mercruiser STERN DRIVES & INBOARDS

parts bulletin

No. 92-8

A. REPLACEMENT PISTONS AND RING SETS

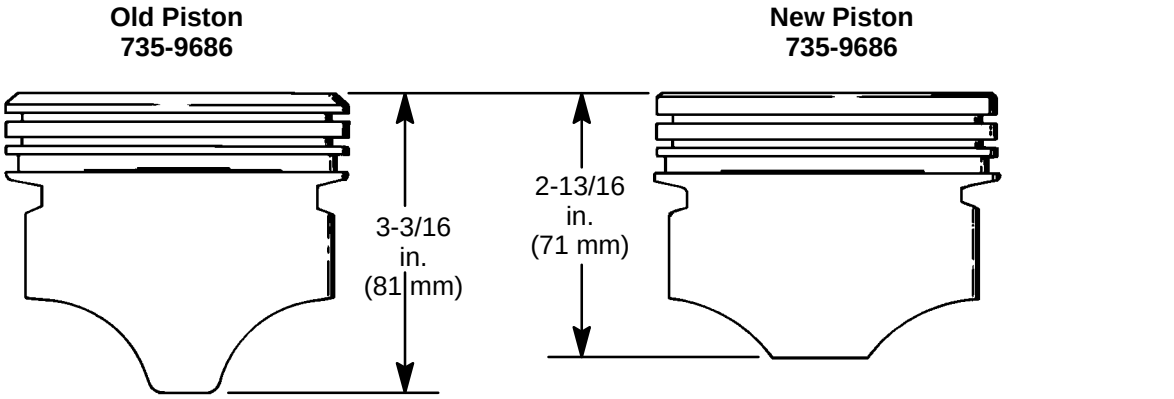
The latest replacement standard pistons (P/N 735-9686) for these engines use a different set of piston rings. The latest piston's oil ring groove is not as deep as the older piston.

The latest replacement piston will be shipped with a set of piston rings.

If piston rings only are required, refer to the drawings before ordering replacement piston ring sets from the chart.
